PIC18F6520/8520

PIC18F6520/8520 Rev. A1 Silicon/Data Sheet Errata

The PIC18F6520/8520 Rev. A1 parts you have received conform functionally to the Device Data Sheet (DS39609B), except for the anomalies described below.

FIGURE 11-1: TIMER0 BLOCK DIAGRAM IN 8-BIT MODE

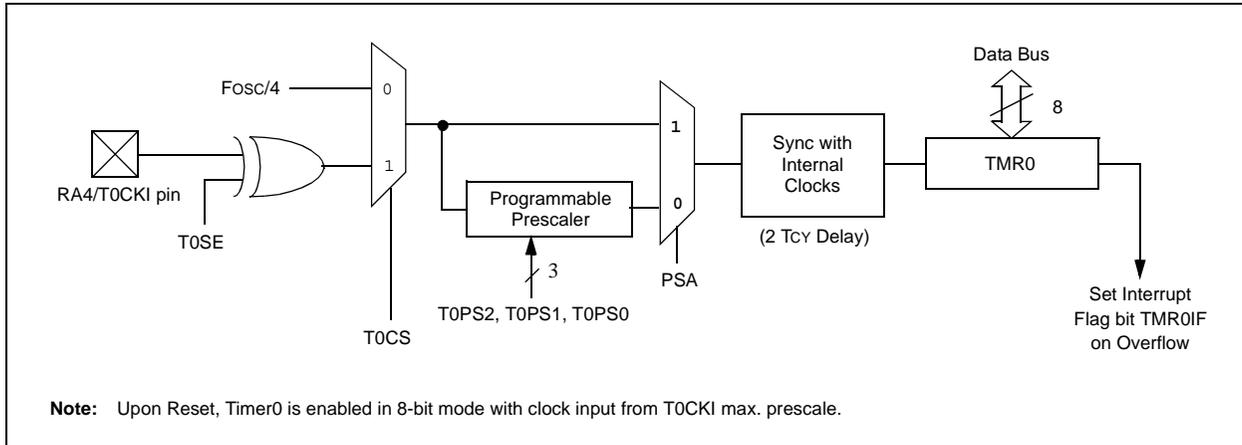
In Figure 11-1 and Figure 11-2 of the Device Data Sheet, the Timer0 Prescaler Assignment (PSA) bits are incorrectly stated. To remedy this, the bit values have been swapped as shown in the figures below.

FIGURE 26-1: PIC18F6520/8520 VOLTAGE-FREQUENCY GRAPH (INDUSTRIAL, EXTENDED)

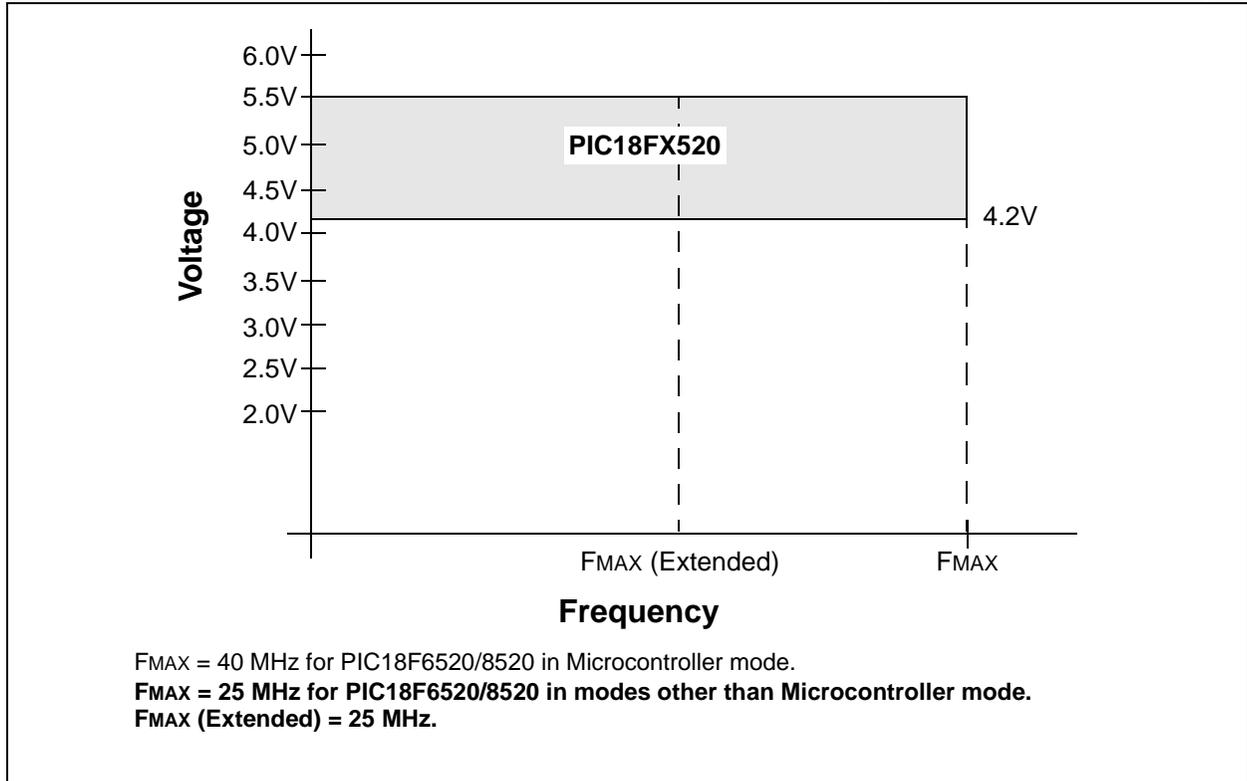
In Section 26.0 “Electrical Characteristics”, Figure 26-1 has been updated to clarify the voltage frequency for Industrial and Extended devices.
